NUMBER
DPS1326

LINE	QUANTITY	UOP	CAT NO.	ITEM NUMBER	UNIT PRICE	AMOUNT
				ADDENDUM NO. 9		
				SEE ATTACHED PAGES.		
				END OF ADDENDUM NO. 9		
0001	1	LS		055-57		
				LIGHTBARS AND SIRENS FOR VEHICLES		
				***** THIS IS THE END OF RFQ	DPS1326 *****	TOTAL:

SOLICITATION NUMBER: DPS1326
Addendum Number: 9

Liberty Series Light Bar Order Form/Worksheet

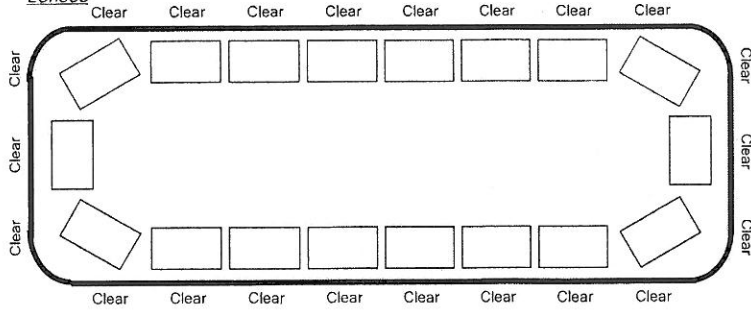
Q5: Section 3.1.1.3 of Addendum 1 states – “The Lightbar shall have a combination of: Four (4) extended corner Linear12 LED lamps (4 Blue); Ten (10) Directional Linear6 (1 Red/8 Blue/1 Amber); and Four (4) LR11 LED Modules (2 LR11 Flashing Alley and 2 LR11 Flashing Takedowns”. There is no diagram included that shows the actual positioning of where these lights are located on the lightbar.

1. Responses to vendor questions attached
2. Diagram to show actual positioning attached. See Exhibit #1
3. The bid opening remains 11/13/2013 at 1:30 pm.

A5: See attached diagram – Exhibit #1.
